## **ADDENDUM #1**

### **ALF SORENSENEN NATATORIUM RENOVATION BID #13/14-015 – PWP# WA-2014-098 BIDS DUE NO LATER THAN: 1:45 PM ON MARCH 5, 2014 PUBLIC BID OPENING: 2:00 PM ON MARCH 5, 2014**

This addendum is to notify all potential proposers of clarifications made to the Bid documents as stated below.

GENERAL COMMENT #3 / ADDENDUM #1

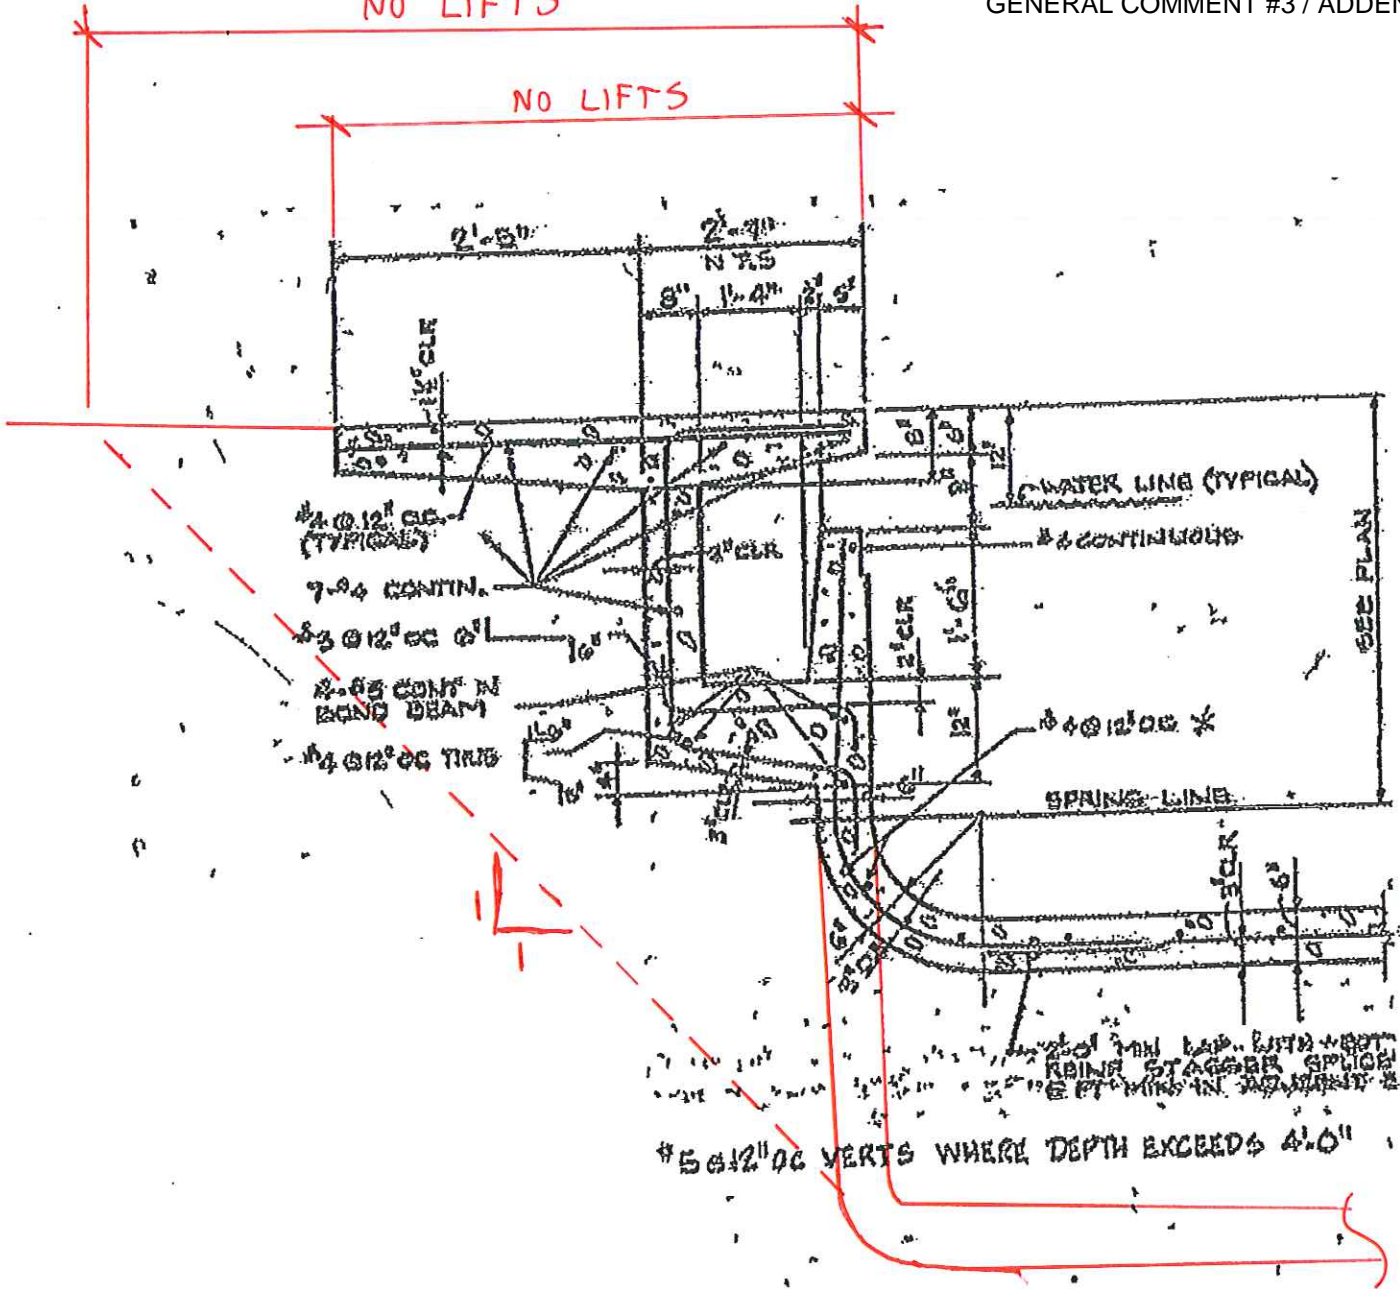
An acceptable weight limit for the concrete deck surrounding pool cannot be verified. Regardless, lifts should stay a minimum of 6 feet away from the edge of pool at all times. *Attached is a sketch from the original construction of that deck with notation added by the Structural Engineer providing criteria for lift distance from pool for pool depths in excess of 6 feet.* Similarly, any temporary construction and/or the use of lifts for this project are the Contractor's means and methods.

Existing Floor Plan  
 August 23, 2013  
 H+K Project No.: 1309  
**A101**

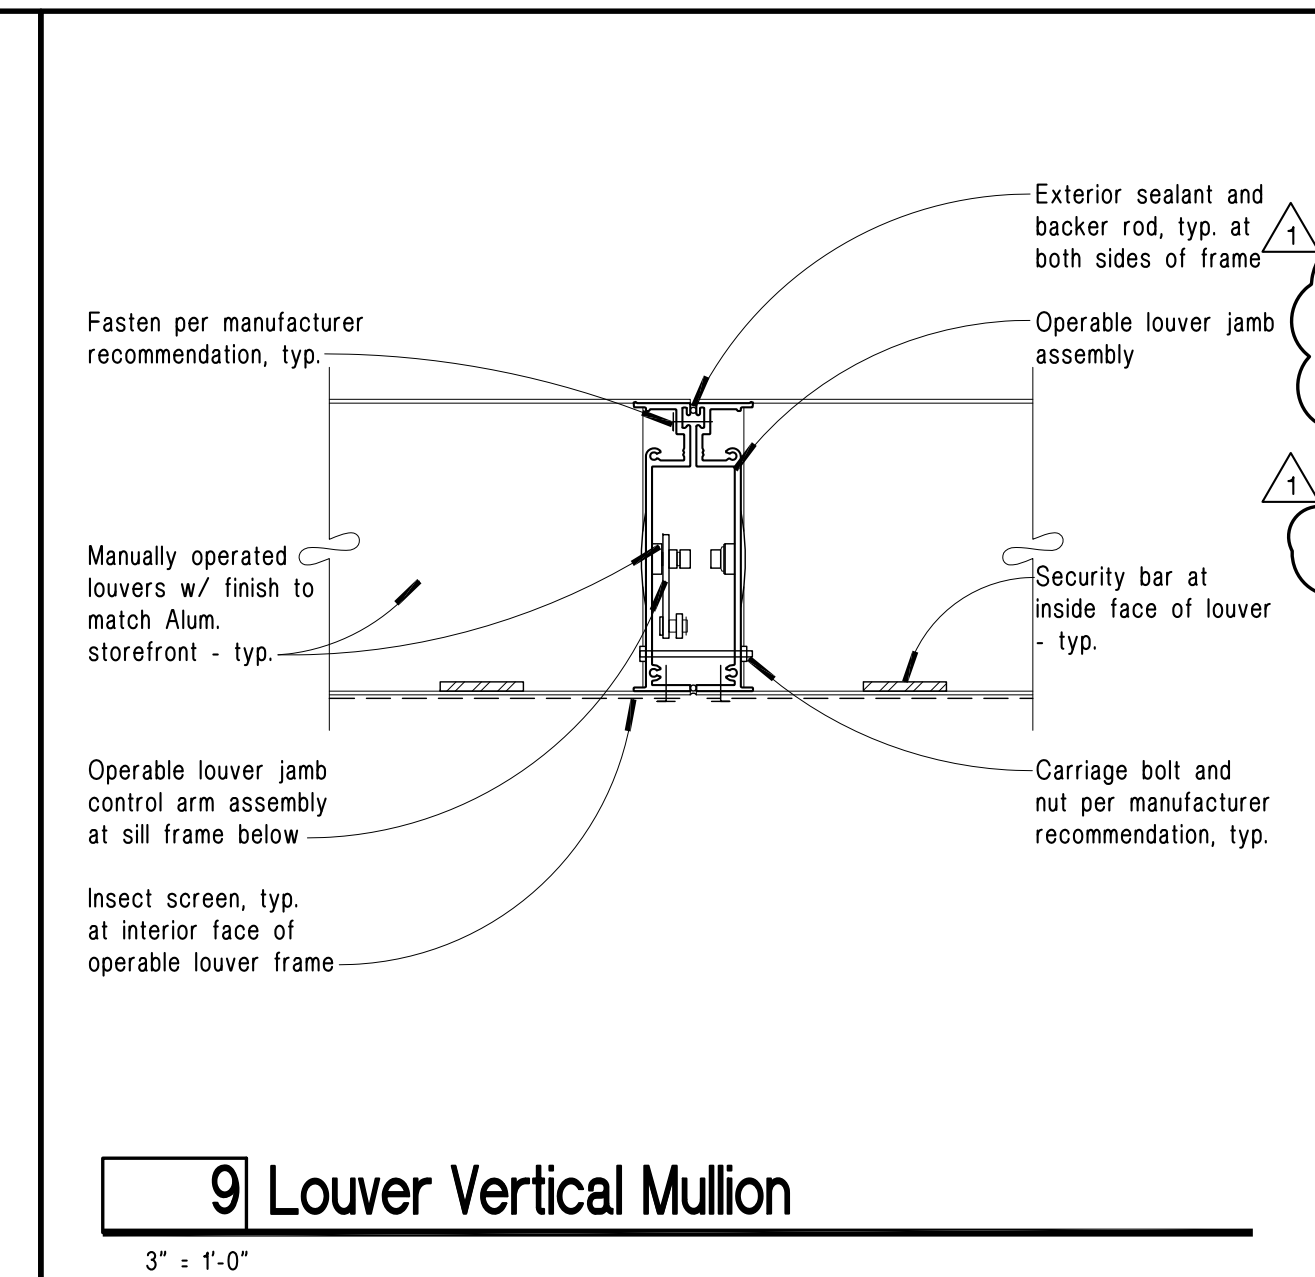
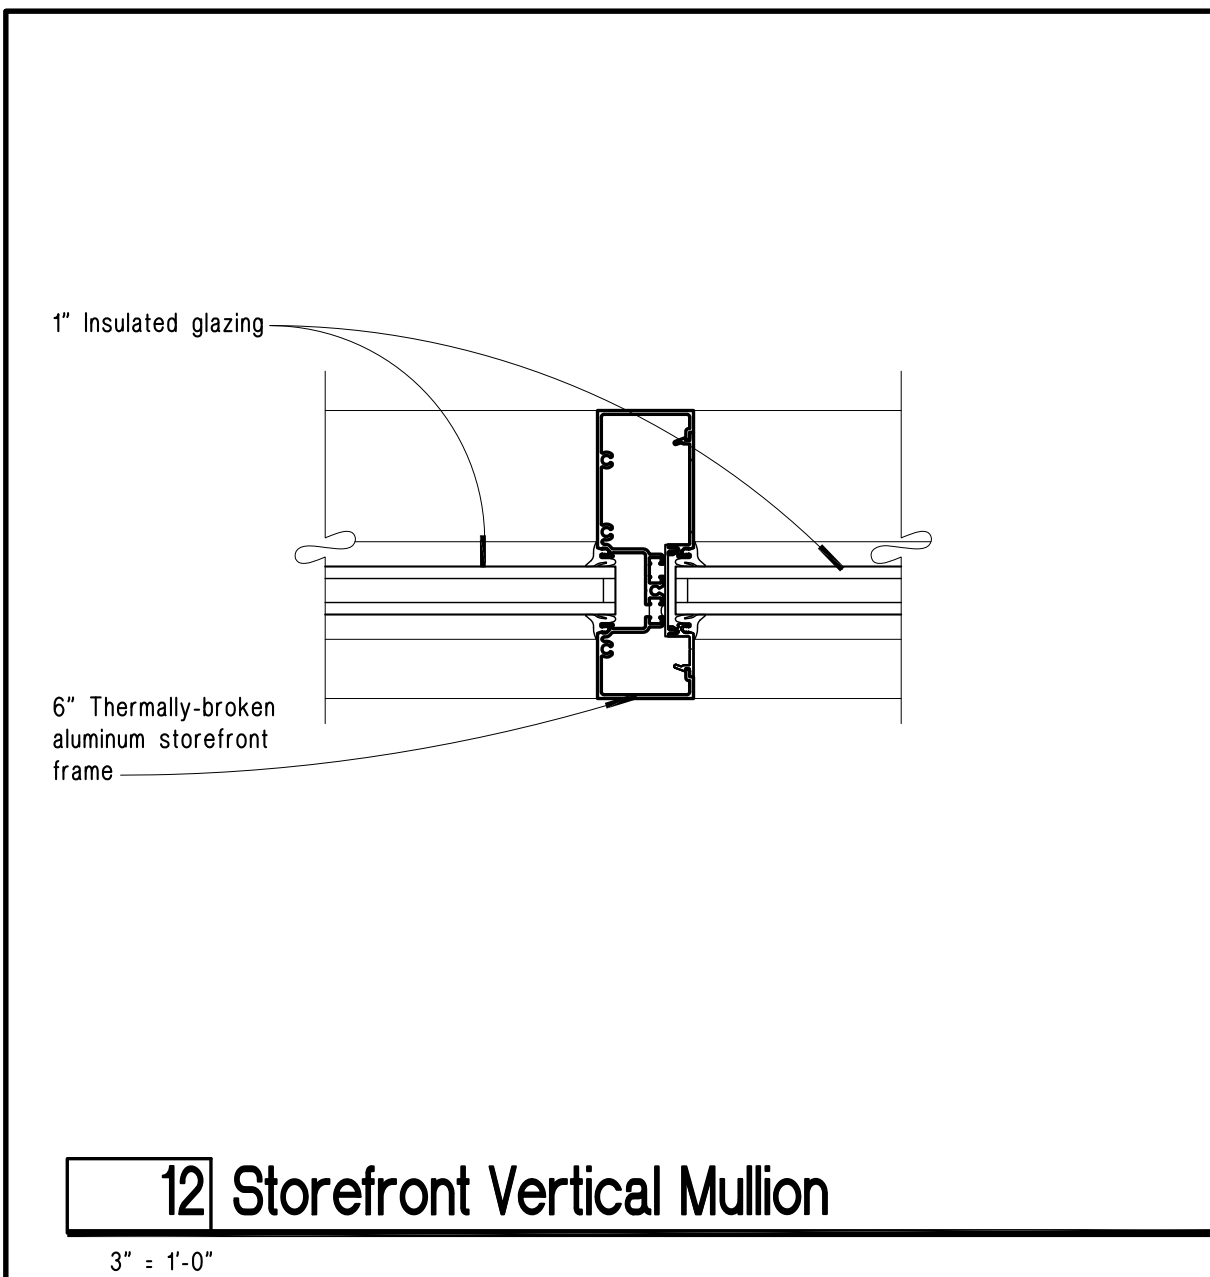
1. Sheet A101 – Existing Floor Plan: *Replace this sheet in its entirety per the attached.*
  - a) Add Drawing 2 “Gymnasium 143 Doors”, including reference to Door 143A and 143B.
  - b) Add reference to Door 110B, 110C, 114 and 115.
2. Sheet A801 – Storefront Elevations and Details: *Replace this sheet in its entirety per the attached.*
  - a) Add Door 110B, 110C, 114, 115, 143A and 143B to “Door Schedule”. These doors are to be included in Bid Pricing as Alternate #1.
  - b) Add 7/A801 reference to frame elevation “C” and “D” of “Storefront and Door Elevations”.
  - c) Add Door Type “F” to “Storefront and Door Elevations”.

**7 Aluminum Tube Frame at (e) Concrete Wall**

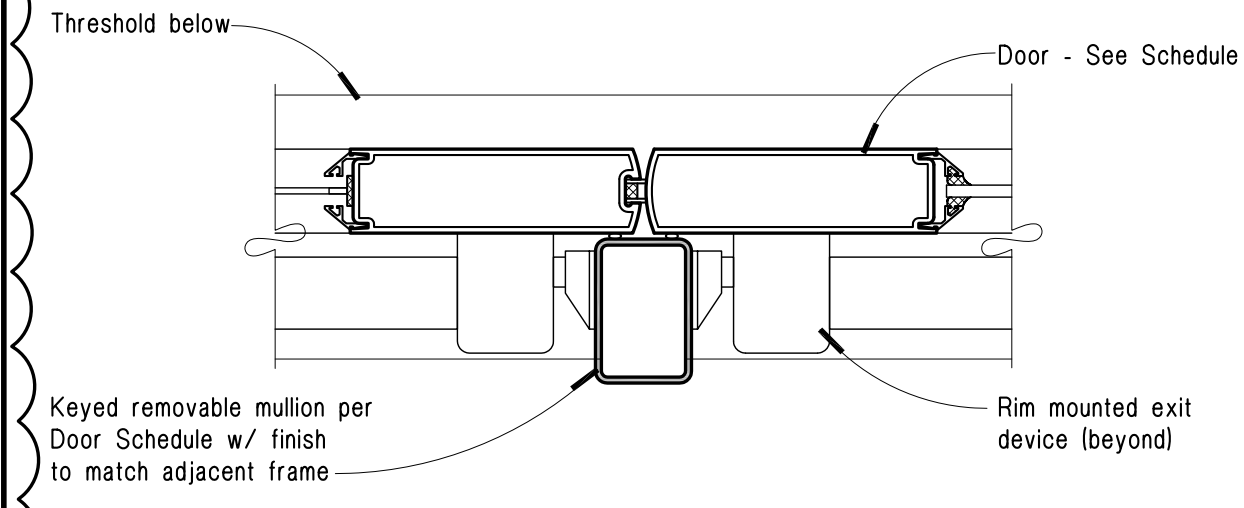
- d) Delete Hardware Group H1 from this sheet. This information is relocated to Sheet A802.
3. Sheet A802 – Door Details: *Replace this sheet in its entirety per the attached.*
- a) Add Door Schedule and Hardware Notes in their entirety.
  - b) Add Door Hardware Group H1, H2, and H3. Group H1 has been modified to require continuous hinges at all FRP doors.
  - c) Detail 7 – Aluminum Tube Frame at (e) Concrete Wall: Add this detail in its entirety.

AIR CONDITIONING -  
 DEMOLITION FLOOR  
 PLAN

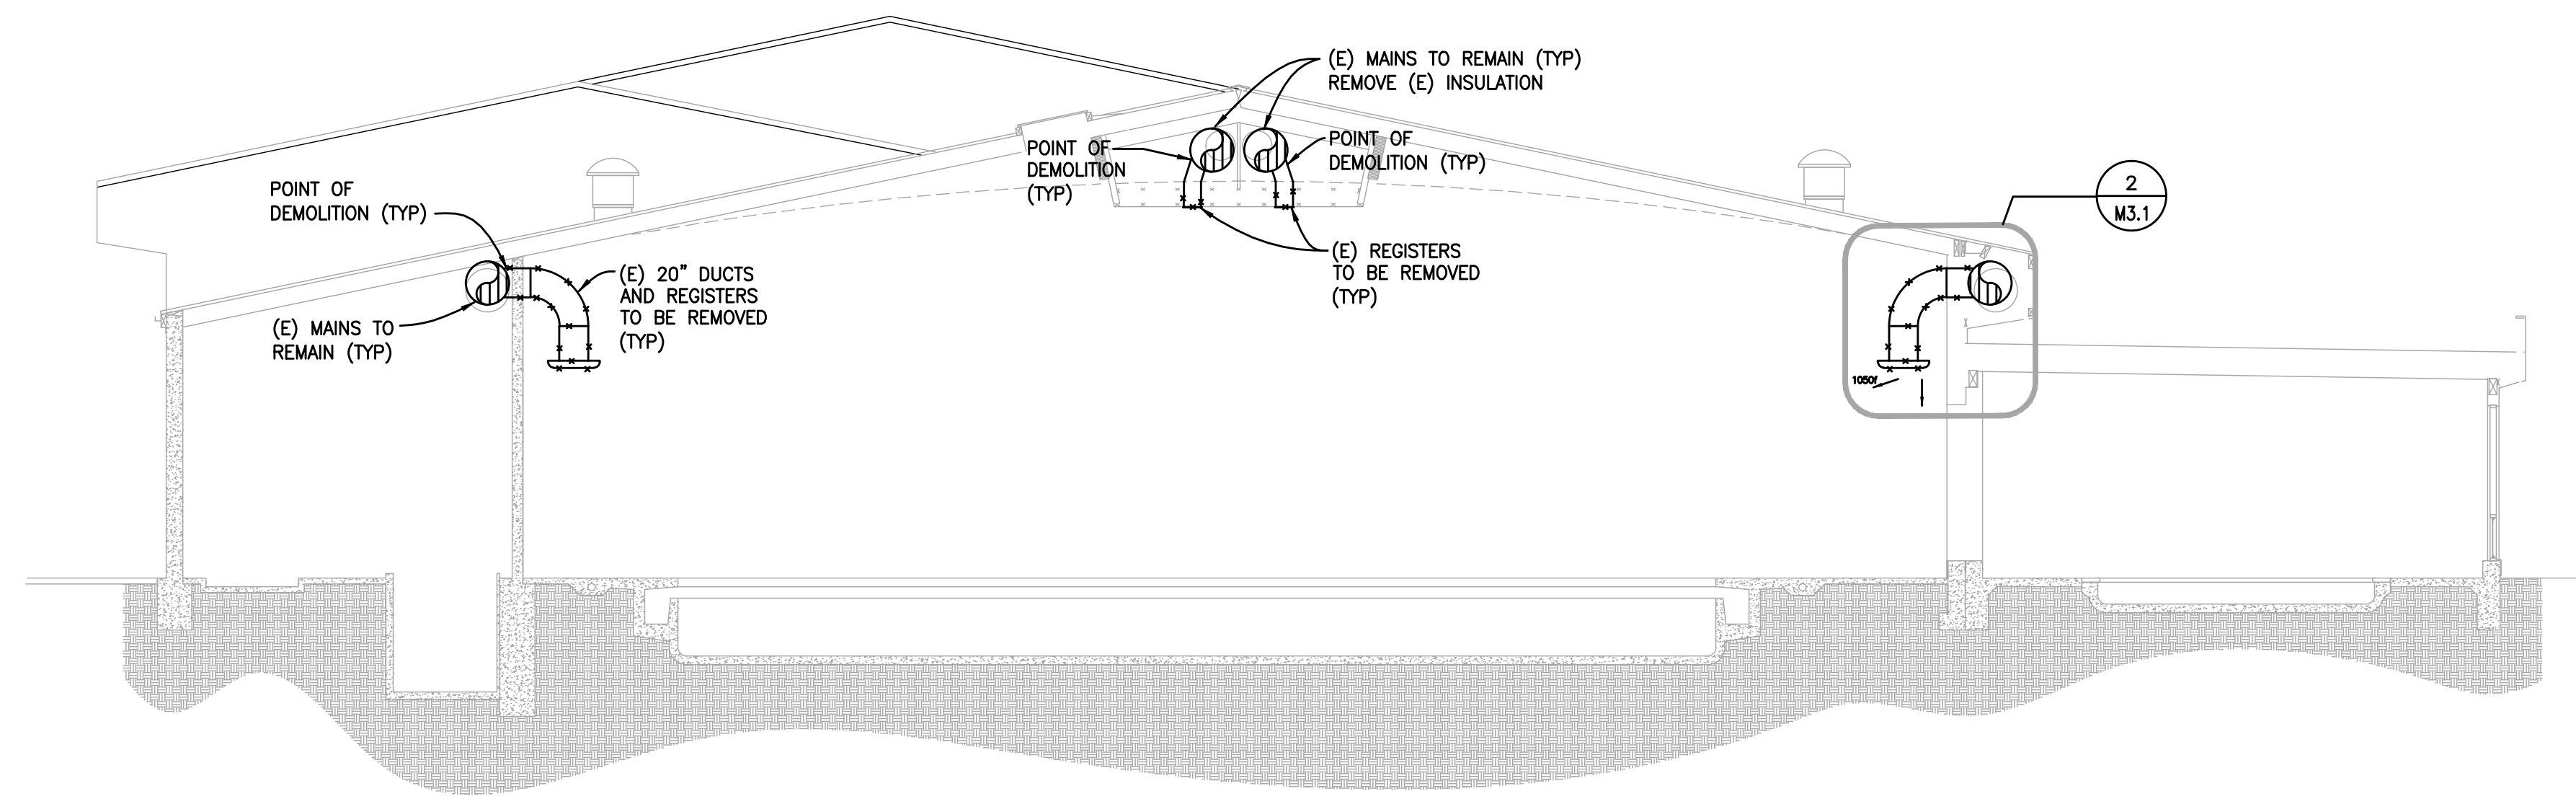
1. Sheet M1.1 – Air Conditioning – Demo Floor Plan: *Replace this sheet in its entirety per the enclosed.*
- a) Add location of existing sprinkler line to help clarify the extent of the existing system within this project’s construction limits.
2. Sheet M3.1 – Air Conditioning Sections: *Replace this sheet in its entirety per the enclosed.*
- a) Detail 2 - Add notations toward right side of detail at end of notation leaders. Notes shall read “(E) Duct to remain”, “(E) Duct Soffit”, and “Lower Roof” from top to bottom respectively.
3. Sheet M6.1 – Air Conditioning – Details: *Replace this sheet in its entirety per the enclosed.*
- a) Detail 5 – Add note for control contractor to coordinate with electrical contractor. The electrical contractor is to provide the enclosure for the exhaust fan controls and switching.
